DATE ~~R~~ Jul.15/02**V2500-A1/A5 PROPULSION SYSTEMS SERVICE BULLETIN**

This document transmits Revision 2 to Service Bulletin EV2500-77-0009 and
 Revision 2 to the Supplement

V2500-ENG-77-0009
 Transmittal - Page 1 of 2

ENGINE – PROVIDE NEW EGT HARNESS JUNCTION BOX TERMINAL NUTS

Engine - Indicating EGT harness and junction box
Fig 1

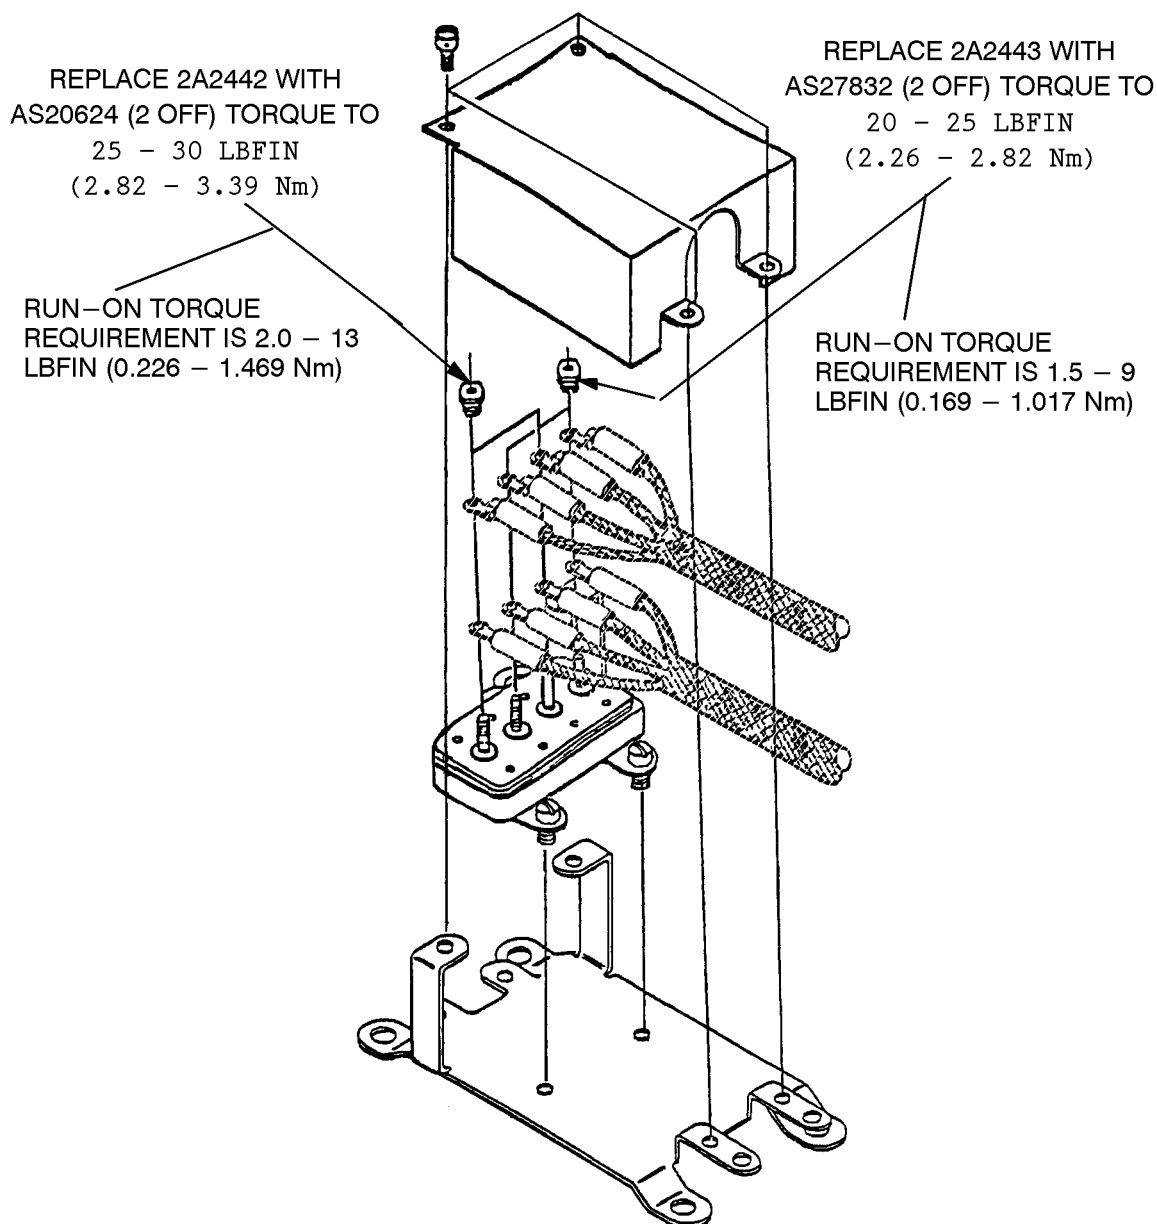
Replace the current spring type locking nut with an elliptical (Deformed Thread) type of locking nut.

- (i) Install 2 larger thread (0.190-32) diameter nuts, PN AS20624 onto the larger thread diameter terminal studs. See Figure 1.
- (ii) Install 2 smaller thread (0.164-32) diameter nuts, PN AS27832 onto the smaller thread diameter terminal studs. See Figure 1.
- (iii) Perform a Run-On Torque Test as follows:
 - (1) Use a torque wrench with a resolution of 1 lbfin (0.113 Nm) or smaller.
 - (2) Run the nut onto the stud until finger tight so that the locking thread is in contact with the stud thread.
 - A Minimum Run-On torque for the smaller thread (0.164-32) diameter nut shall be 1.5 lbfin (0.169 Nm).
 - B Maximum Run-On torque for the smaller thread (0.164-32) diameter nut shall be 9 lbfin (1.017 Nm).

(iv) Torque the larger thread (0.190-32) diameter Nut to 25 - 30 lbfin (2.82 - 3.39 Nm).

(v) Torque the smaller thread (0.164-32) diameter Nut to 20 - 25 lbfin (2.26 - 2.82 Nm).

Harness and junction box stud replacement
Fig 2

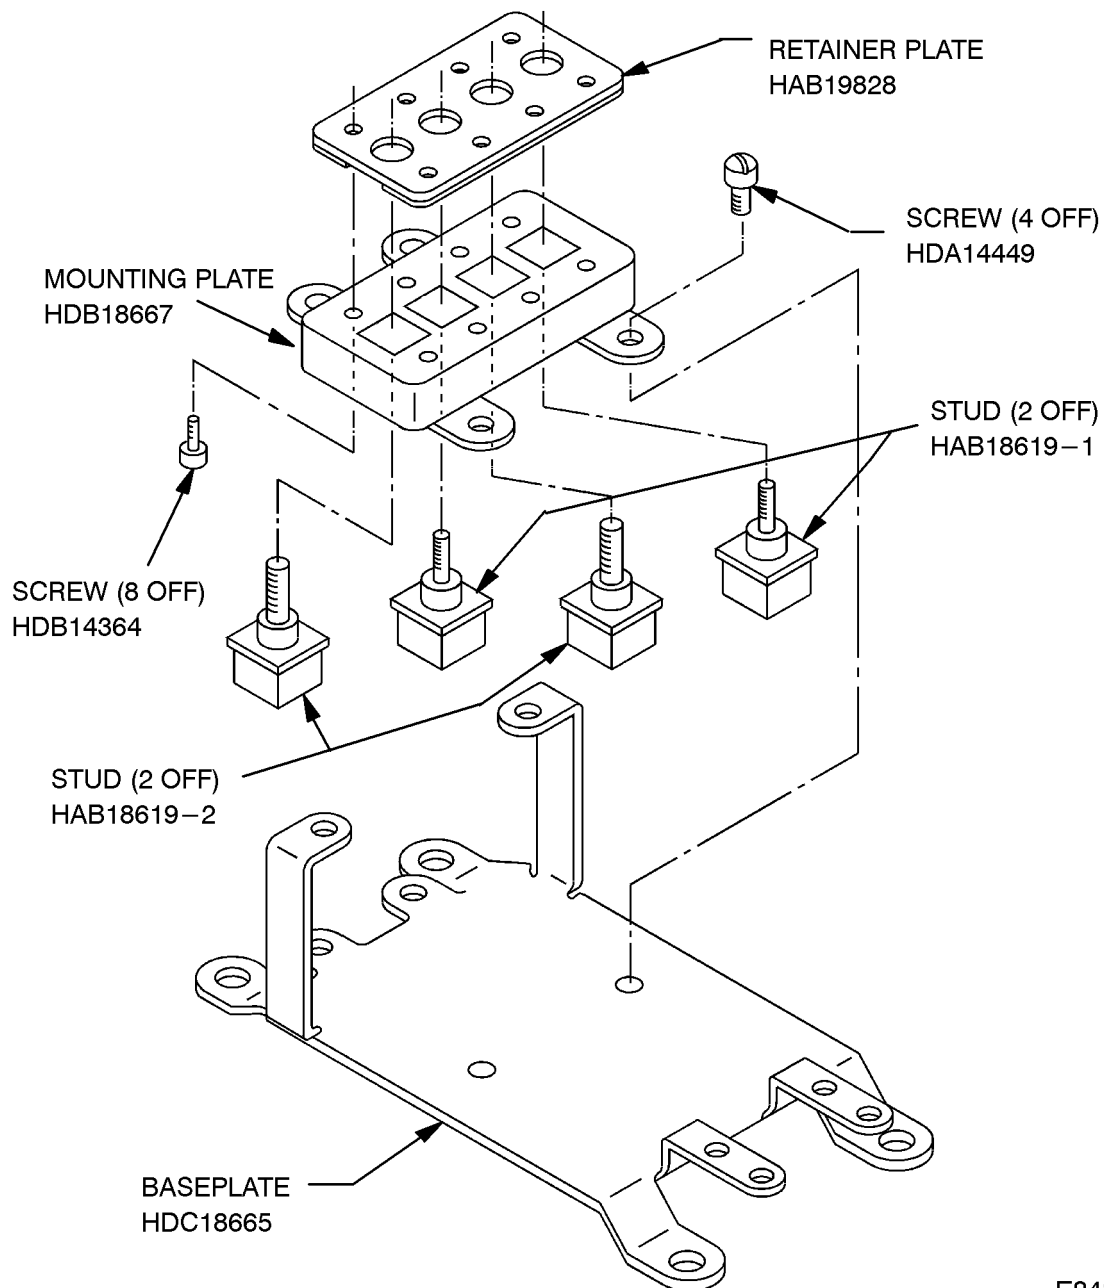
(i) Remove the safety wire and four Screws PN HAD14449. See Figure 2.

(ii) Remove Mounting Plate PN HDB18667. See Figure 2.

(iii) Remove the safety wire and eight Screws PN HDB14364, and disconnect the Retainer Plate PN HAB19828 from the Mounting Plate PN HDB18667. See Figure 2.

(iv) Identify terminal positions for Studs PN HAB18619-1 or PN HAB18619-2 with labels, and remove the Stud PN HAB18619-1 or PN HAB18619-2 from the Mounting Plate. See Figure 2. Dispose of the removed Studs in an approved method.

(v) Install new Studs PN HAB18619-1 and/or PN HAB18619-2 in the Mounting Plate PN HDB18667. See Figure 2.

(vi) Install the Retainer Plate PN HAB19828 over the new Studs on to the Mounting Plate PN HDB18667. Line up the Screw holes on the Retainer Plate with those on the Mounting Plate and attach the Retainer Plate to the Mounting Plate with the eight Screws PN HDB14364. See Figure 2. Safety wire all screws.

(vii) Attach the Mounting Plate PN HDB18667 to the Base Plate PN HDC18665) with the four Screws PN HDA14449. See Figure 2. Safety wire all screws.

R Family tree V2500 thermocouple junction box and nuts Ref Catalog Seq. No. 77-21-43
R Fig 01 Item 016, Item 017, Item 018
Fig 3

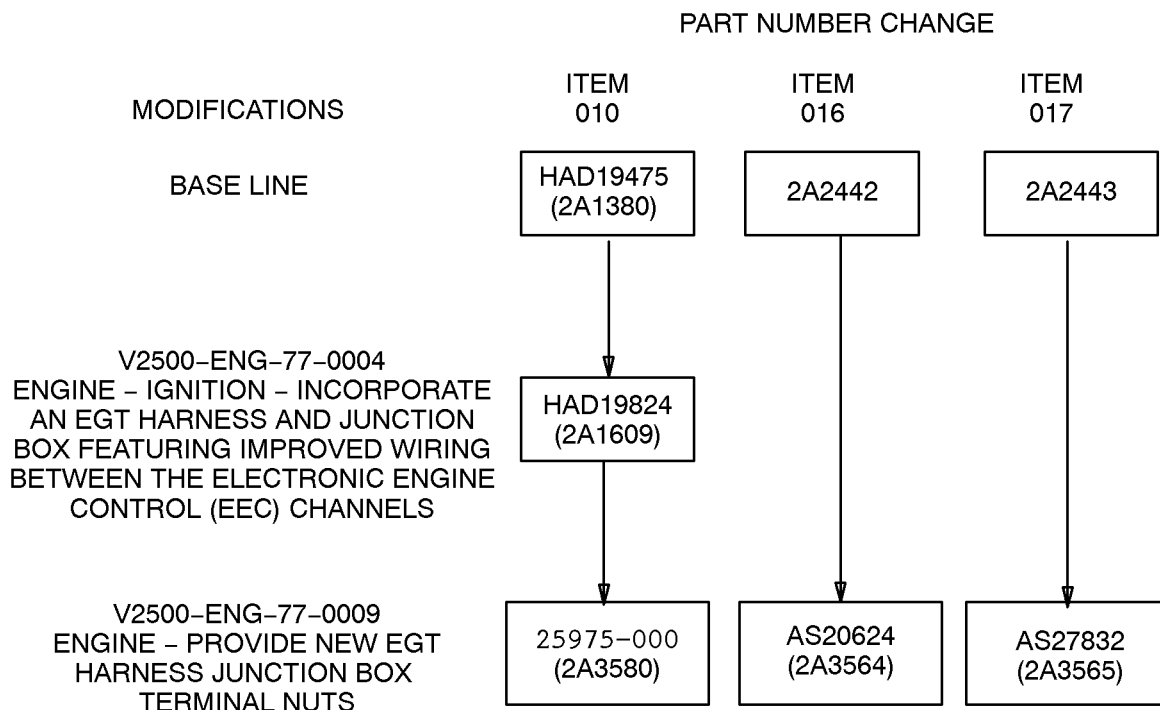
Parts Progression To Show the Changed Part in Relation to Other Parts
